84451 COMSEC 802-6976052
C3-222
DRAWING DATE 01-03-02
REV B

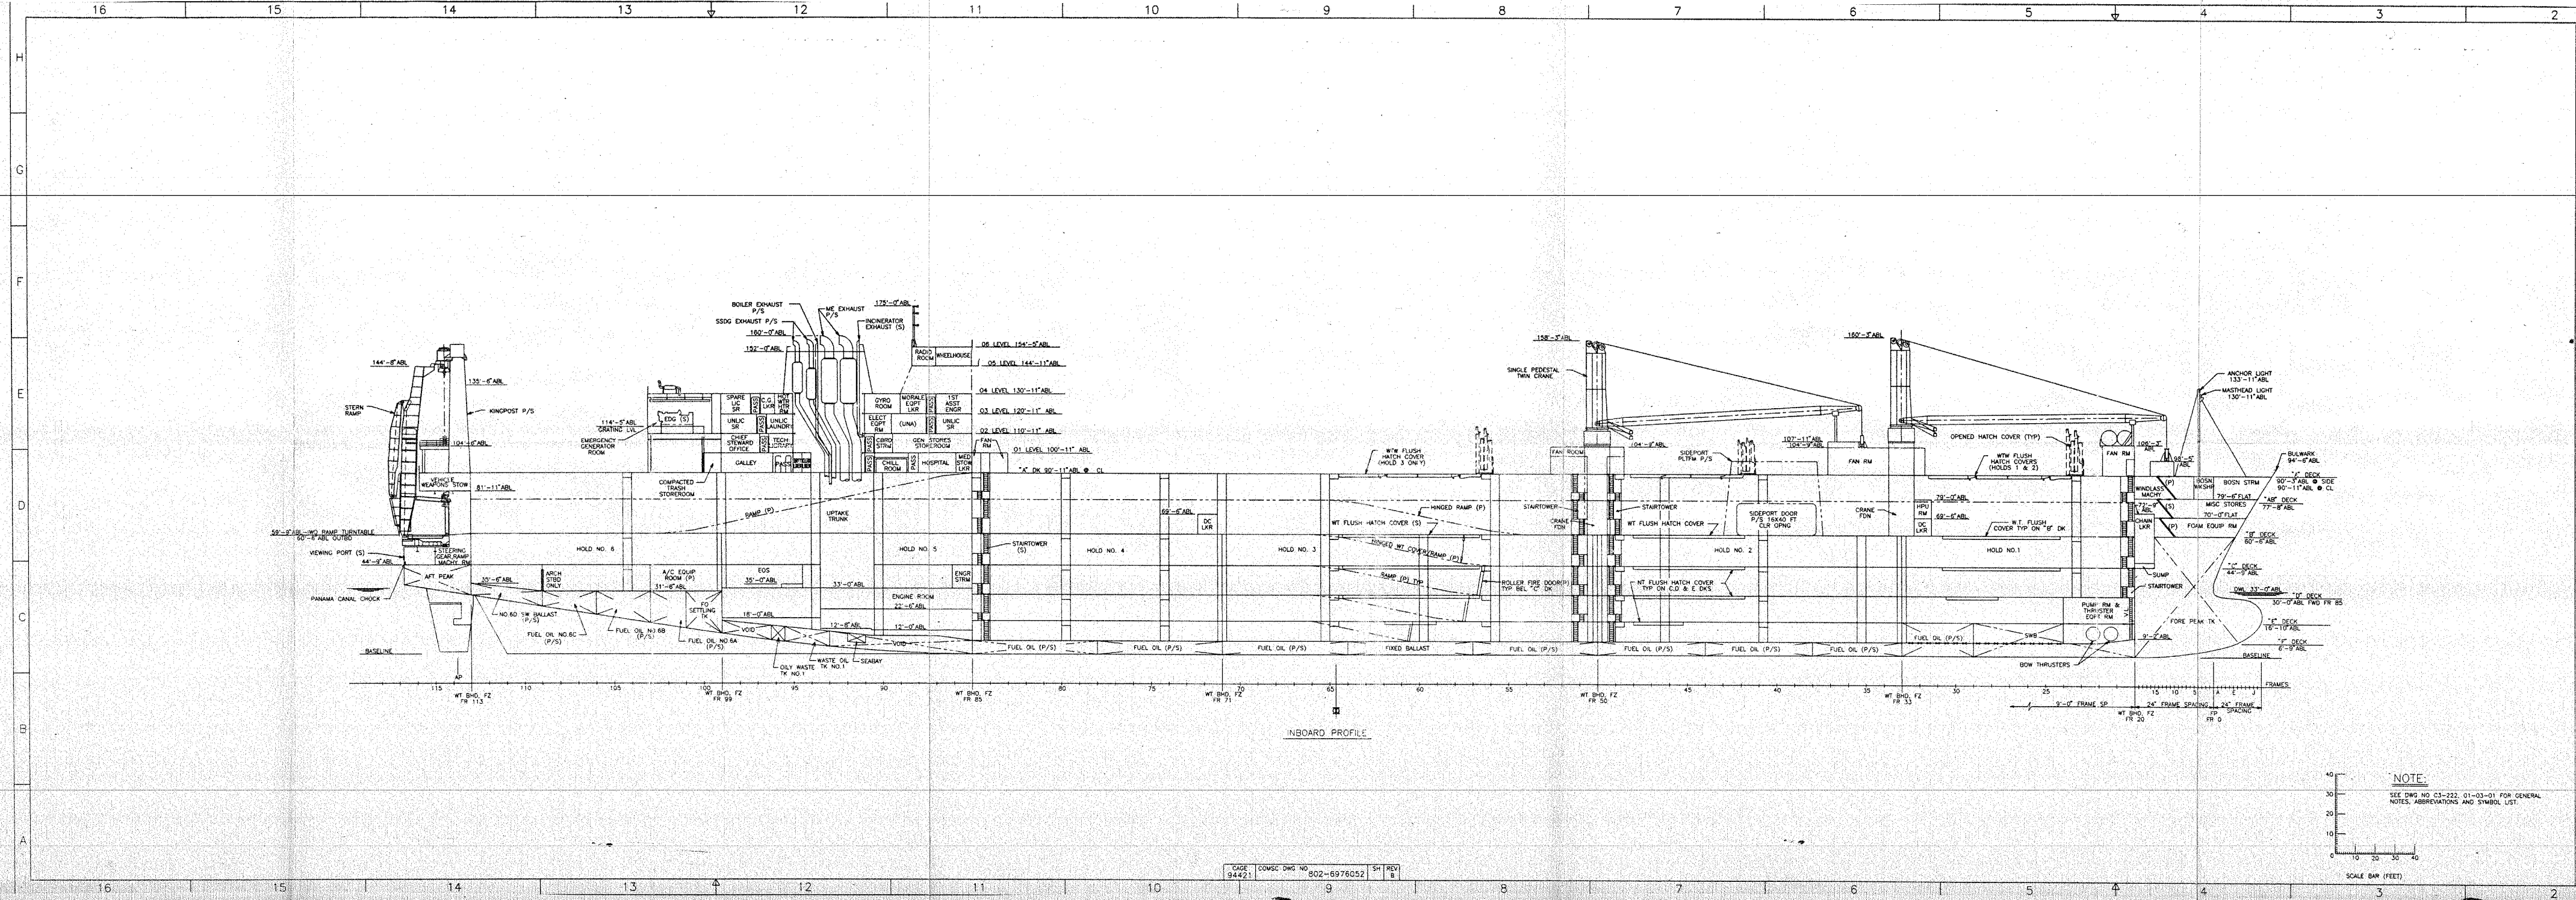
REVISIONS		DESCRIPTION
REV	SH	DESCRIPTION
1	0	DELETED INDICATION OF DK AT SIDE
2	0	CHANGED CONFIGURATION OF FAN RM AT FR 33
3	0	CHANGED CRANE BOOM CONFIGURATION TO BE PARALLEL W/BASELINE
4	0	DELETED VENT TRUNKS AT FR 33.50 & 85
5	0	DELETED STARTTOWERS AND VENT TRUNKS AT FR 71
6	0	ADDED STARTTOWER AT FR 50
7	0	ADDED STARTTOWER AT FR 85
8	0	ADDED TRANSV BOX GDS AT FR 71.75, 80.85 & 104
9	0	NOT USED
10	0	DELETED KNUCKLES FROM "A" & "B" DECK
11	0	LOWERED "A" DECK 15' TO SUIT
12	0	REMOVED ACCOMMODATION HOUSE ELEVATIONS TO SUIT LOWERING OF "A" DECK
13	0	REMOVED ELEVATIONS OF PLATS FWD FR 20 TO SUIT LOWERING OF "A" DECK
14	0	RELEASED RESERVATION #1
15	0	ADDED GENERAL NOTE, ABBREVIATION & SYMBOL LIST
16	0	ADDED SCALE BAR
17	0	INDICATED CENTERLINE INCLINED LADDERS AT FR 10
18	0	NOT USED
19	0	ADDED ABOVE BASELINE ELEVATIONS AT VARIOUS HOUSE TOPS
20	0	INDICATED MAIN MAST ON DRAWING
21	0	CORRECTED ABBREVIATIONS FOR LICENSED AND STATE ROOM

22	0	CORRECTED OUTLINE OF DGG TO 3516 CAT, ADDED GRATING LEVEL AND LOWERED HOUSE TOP TO SUIT NEW GENERATOR
23	0	RECONFIGURED PUMP ROOM & THRUSTER EQUIPMENT ROOM, DELETED VOID TWO OF BOW THRUSTERS TO SUIT
24	0	DELETED CALLOUT FOR FUEL OIL BTHN FR 20 & 29 AT INNERBOTTOM AND ADDED NT INDICATIONS IN "A" DECK FR 24 TO 29 TO INDICATE INCORPORATION OF INNERBOTTOM TK TO DK SWB TK
25	0	REMOVED STARTTOWER AT FR 50 TO SUIT STRUCTURAL DEVELOPMENT
BY SEM 8/11/94		APPROV'D 8/12/94
VAR	1	RELOCATED SIDE PORT DOORS TO CENTER ON FR 40 TO SUIT DEVELOPMENT
VAR	2	INCORPORATED TURNING BEAM AT TOP OF KING POST AND CORRECTED LEAN OF STERN RAMP TO SUIT DEVELOPMENT
VAR	3	HEIGHT OF FAN ROOM AT FR 20 CHGD FROM 108'-1" ABL TO 108'-3" ABL TO SUIT VENT COMPOSITE DEV
VAR	4	INDICATED CENTERLINE STANCHIONS AT FR 33.50 AND 50 TO CORRECT
VAR	5	VEHICLE STORAGE PLAT ADDED IN REV A, ITEM 9
VAR	6	DELETED TO SUIT DEVELOPMENT
VAR	7	THE ELECTRICAL EQUIP ADDED IN REV A, ITEMS 17 AND 21 HAVE BEEN DELETED TO SUIT DEV

VAR	8	REVISED CALLOUTS OF COMPARTMENTS BETWEEN FR 94 & 95 ON "A" DECK TO CORRECT
VAR	9	ADDED APPROPRIATE SYMBOL TO INDICATE MASHUP
VAR	10	INDICATED HATCH COVER HINGES AT "A" DECK
VAR	11	REVISED HOLD 3 "F" DECK FIXED RAMP TO HINGED WT COVER/RAMP TO SUIT DEVELOPMENT
BY SEM 6/21/95		APPROV'D 6/22/95
PENDING DEVELOPMENT		RESERVATIONS
UNIT:		CDRL
8031-2		
DISTRIBUTION STATEMENT		THIS DOW INCORPORATES THE FOLLOWING CHANGE ORDERS:
APPROVED FOR PUBLIC RELEASE DISTRIBUTION IS UNLIMITED		
2375	T-AKR 302	VESSEL
2374	T-AKR 301	VESSEL
2373	T-AKR 300	VESSEL
2372	T-AKR 299	VESSEL
2371	T-AKR 298	VESSEL
2370	T-AKR 297	VESSEL
2369	T-AKR 296	VESSEL
2368	T-AKR 295	VESSEL
2367	T-AKR 294	VESSEL
2366	T-AKR 293	VESSEL
2365	T-AKR 292	VESSEL
2364	T-AKR 291	VESSEL
2363	T-AKR 290	VESSEL
2362	T-AKR 289	VESSEL
2361	T-AKR 288	VESSEL
2360	T-AKR 287	VESSEL
2359	T-AKR 286	VESSEL
2358	T-AKR 285	VESSEL
2357	T-AKR 284	VESSEL
2356	T-AKR 283	VESSEL
2355	T-AKR 282	VESSEL
